Product Change Notification – PCN F01/2021

**SUBJECT: E71/33/32, E55/28/25, E55/28/21, E56/24/19, E42/21/20, E42/21/15, core family – visual appearance change**

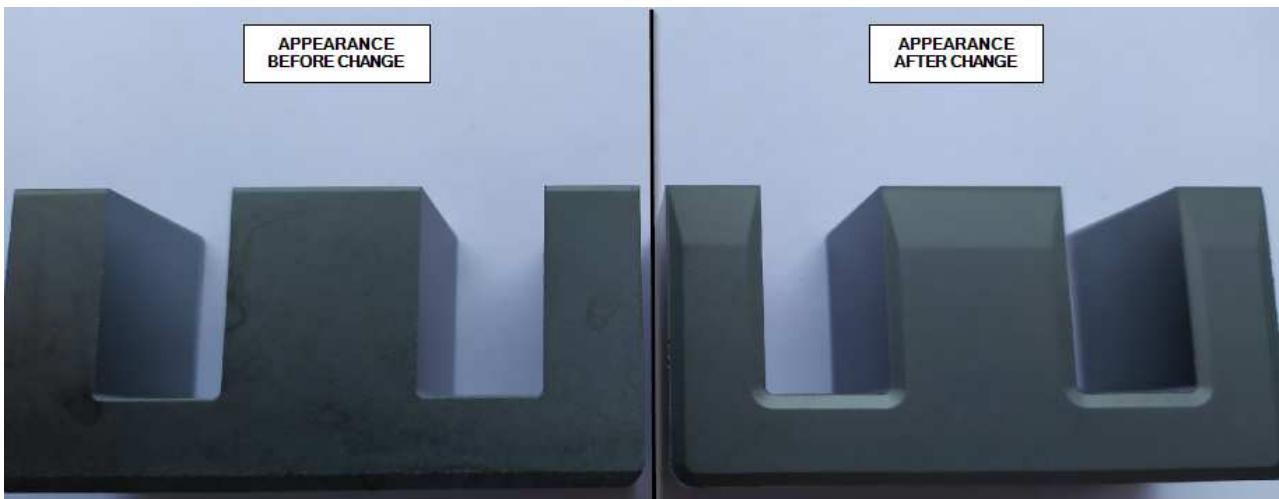
E-cores, as listed above will change visual appearance by slightly increased chamfer on the surface as presented on below photos:
